PLAN COMMISSION

SP-15-21 **Trinitas Ventures**

3216 E 3rd Street

The District at Latimer Square Bloomington, Indiana Site Plan Approval

TRANSPORTATION PLAN STREET GRID NC-13 STREET ALIGNMENT

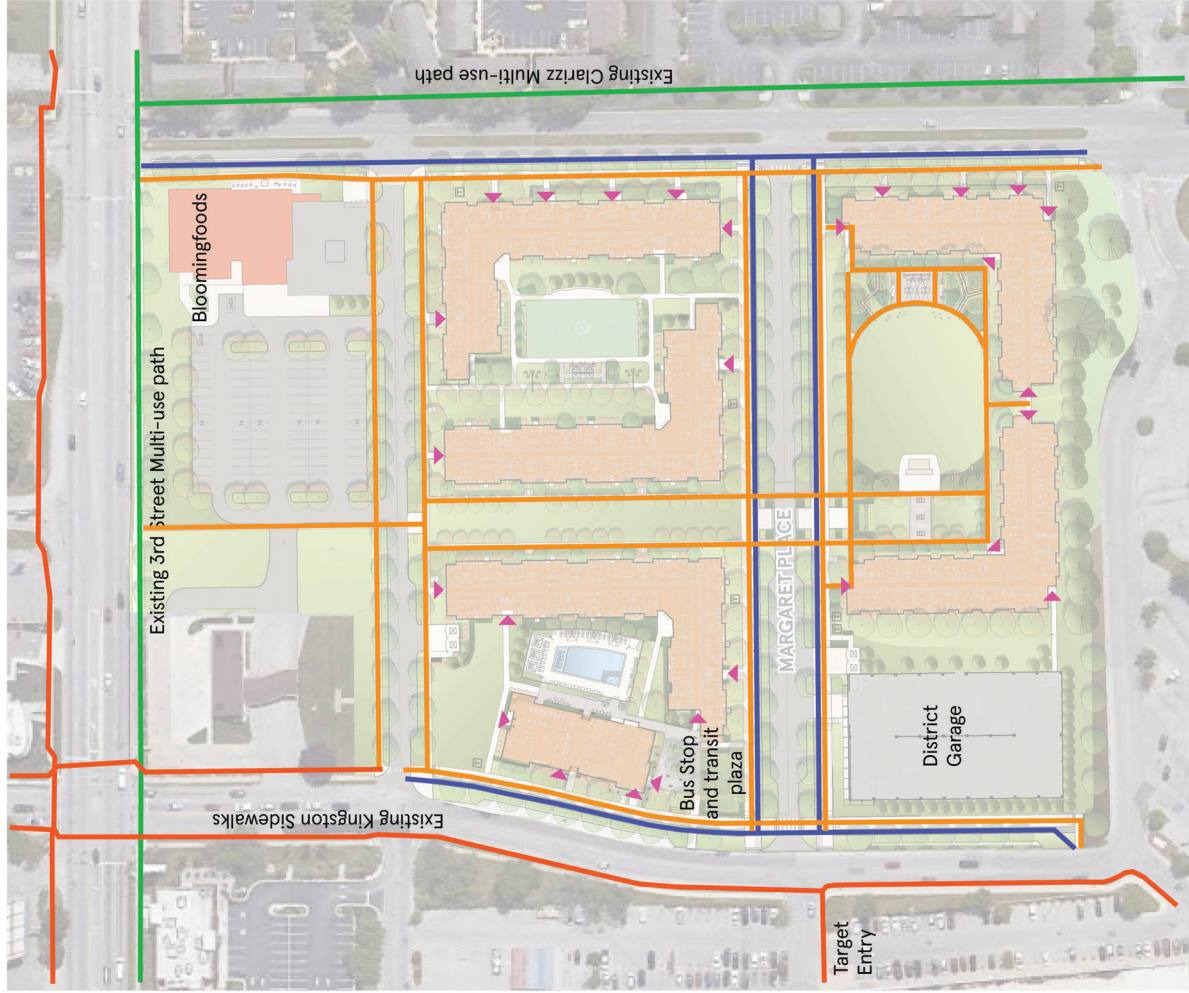
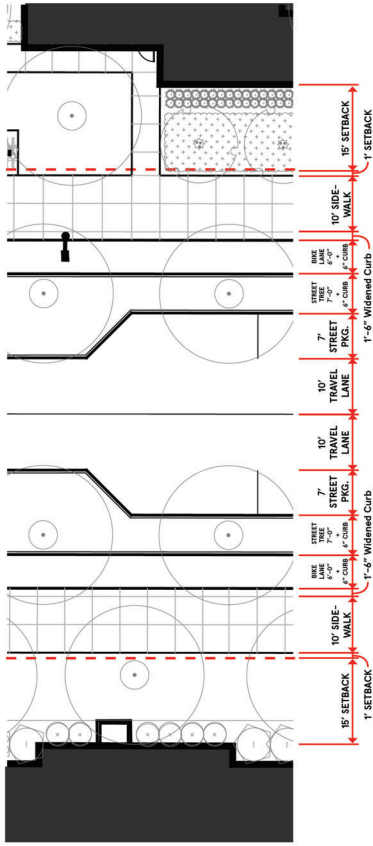
The Transportation Plan shows two street connections, NC-13 and NC-15. Their descriptions both say, "Provide new street grid as part of any future redevelopment of the area. The grid should be established with block length of 350' - 550'." (pg. 54) Please see Sheet A002 for our block and street grid extension diagrams.

Margaret Place has been revised to the General Urban Street Section. Please see our alignment diagram on sheet A002 illustrating the potential alignment to Hunter Avenue. No dedicated turn lane has been provided to maintain a narrower street section. Protected bike lanes are provided on Margaret Place, Kingston Drive and Clartiz Boulevard.

1 PARKING GARAGE - MARGARET PLACE FACADE

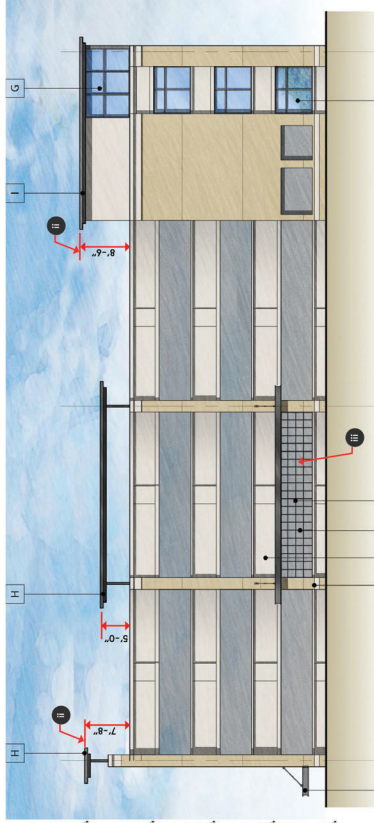
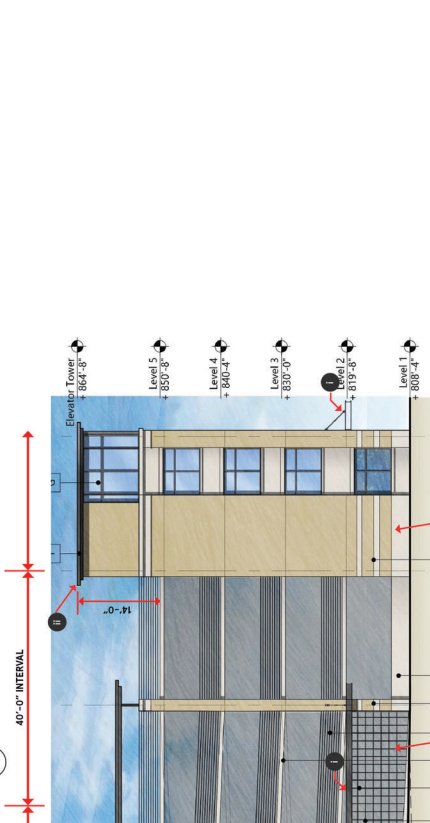
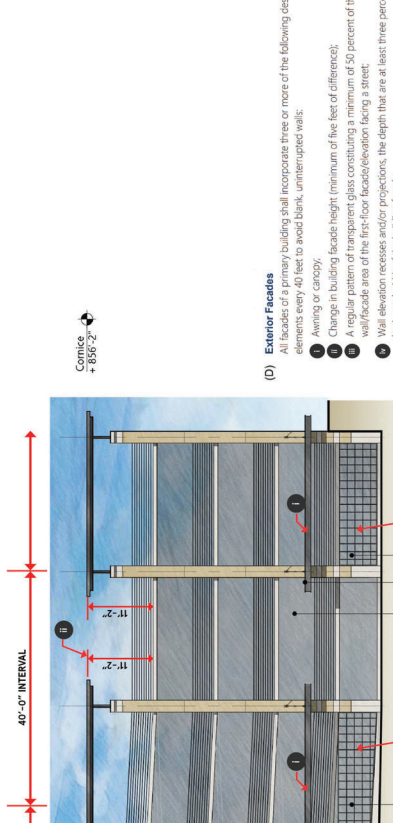
- Architecture
 - Parking Garage- The elevations for the parking garage do not meet the architectural
 - The parking garage design has been revised to meet the UDO requirements.
 - Please see sheet A011 for revised elevations.
 - The elevations for the residential buildings do not meet the required 3% modulation depth, the depth of the modulation is measured from the face of the building and
 - Additional comments regarding architecture may be passed along once a review is completed by Schmidt and Associates.
 - Where it is not possible to meet the 3% modulation we have employed the 50% Green Garage (GG) as documented on sheet A011.
 - Please show the location of any roof mounted HVAC and utility structures, including electrical transformers or utility boxes.
